# Clause 169 Multi-Drop Power over Ethernet (MPoE)

CHAUVE Vincent affiliated to Schneider Electric

24/01/2024

- **Use case 1 : Switchboard Application based on predefined clusters**

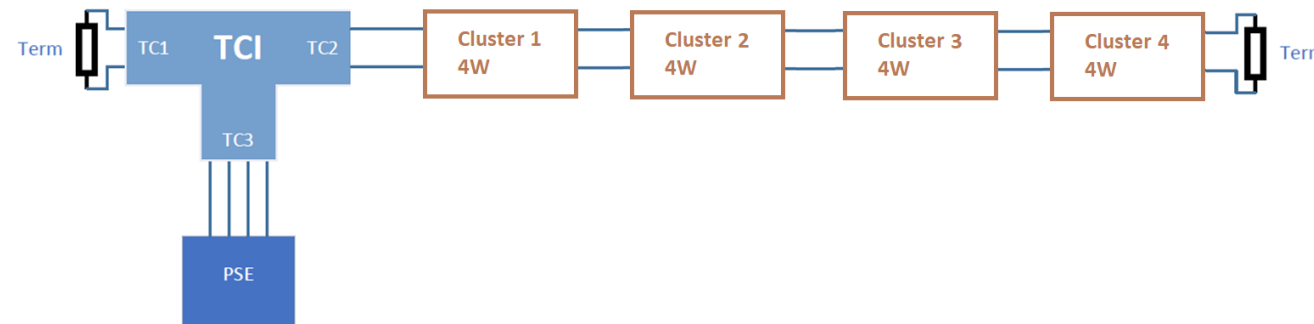
- Electrical cabinet contains several instances of a predefined cluster.
- Each cluster is a consistent functional unit.
- Cabinet builder monitors power consumption at clusters granularity. Individual devices inside clusters must not be monitored.

- 1× breaker
- 1× I/O block
- 1× display unit; designed for outdoor readability

- **Use case 2 : Motor Drive Application**

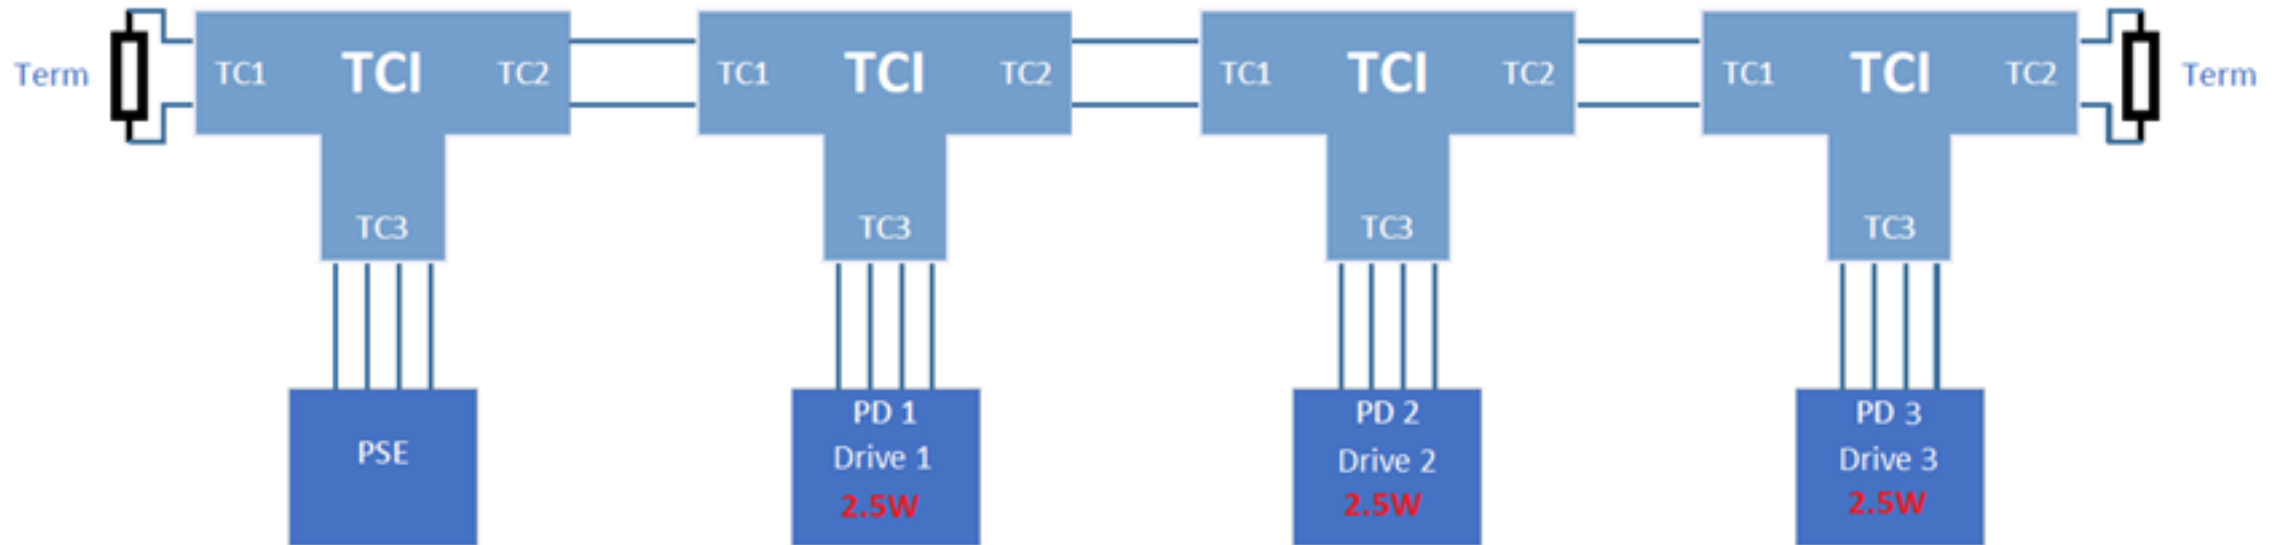
- Electrical cabinet contains several instances of a motor drive unit; with predefined power requirements above 2 W

- **Possibility to use a MPSE from another supplier → need to be compliant with IEEE 802.3da**

• Table 169-7-MPD Power Supply Limits

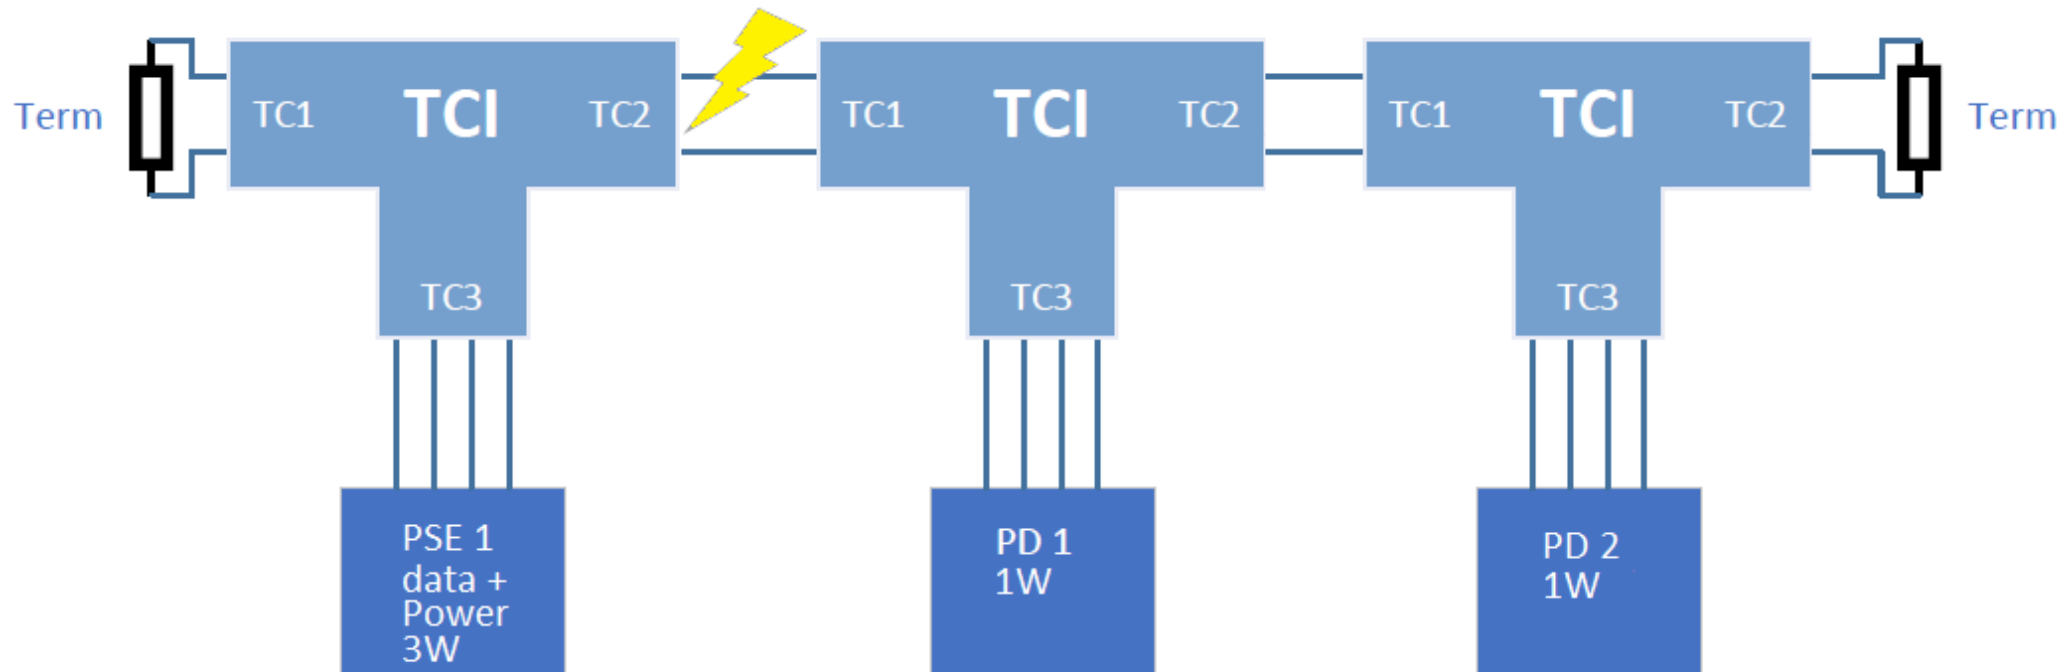
- Type 0 with 16 Nodes at 1W , means a maximum power BUS at 16W
- **Keep the same MPSE Output Power Capability** (16W) without constraining the unit MPDs

•  $P_{MPD(max)}$  type 0 = ~~1W~~ → 16W

$P_{MPD(max)}$  type 1 = ~~2W~~ → 32W.

- Upgraded system

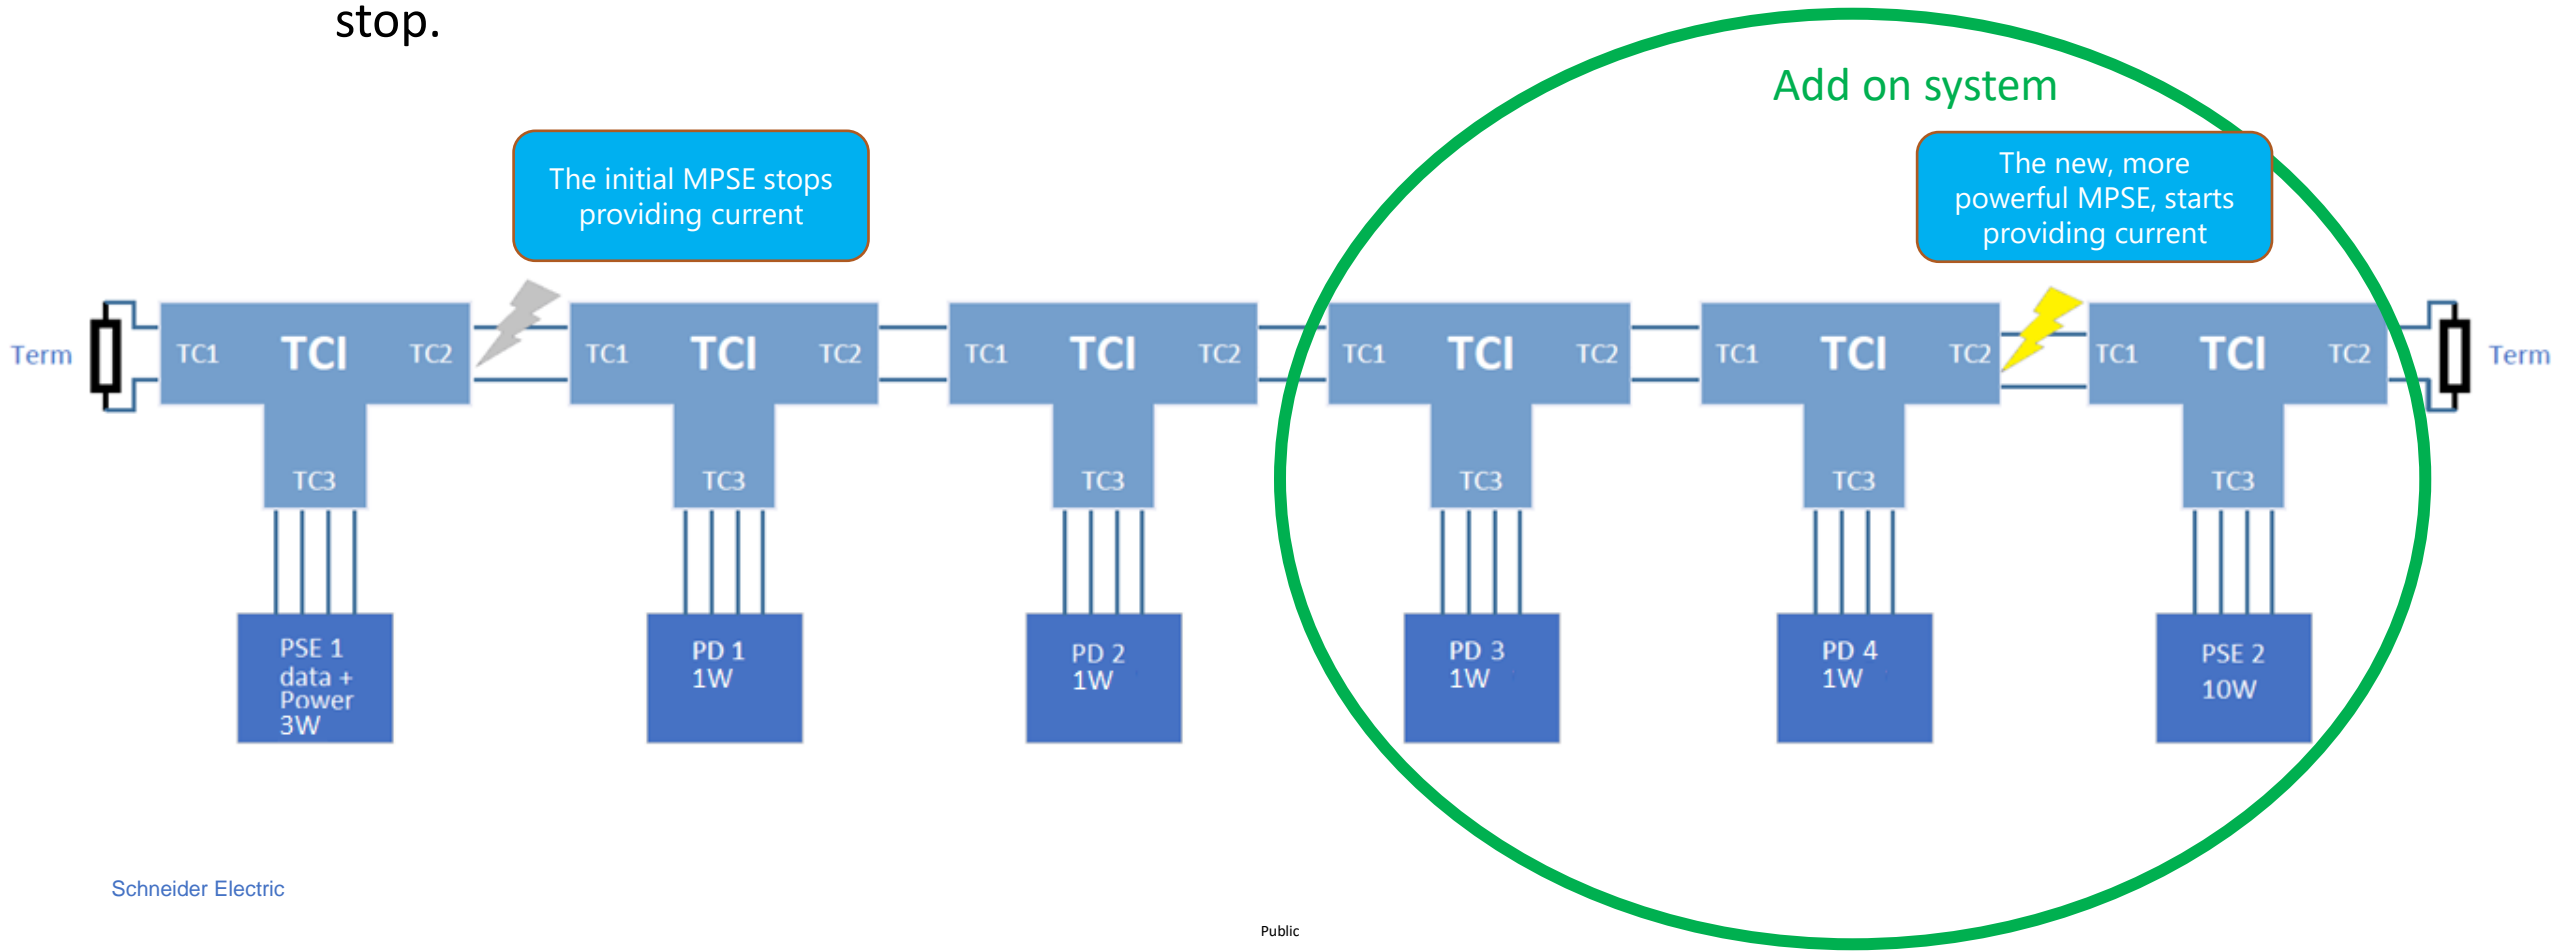
- No adding another MPSE to the BUS but “replacing” the existing MPSE with a more powerful one.
- The system must not be interrupted; i.e. the MPSE replacement must not cause the MPDs to stop.
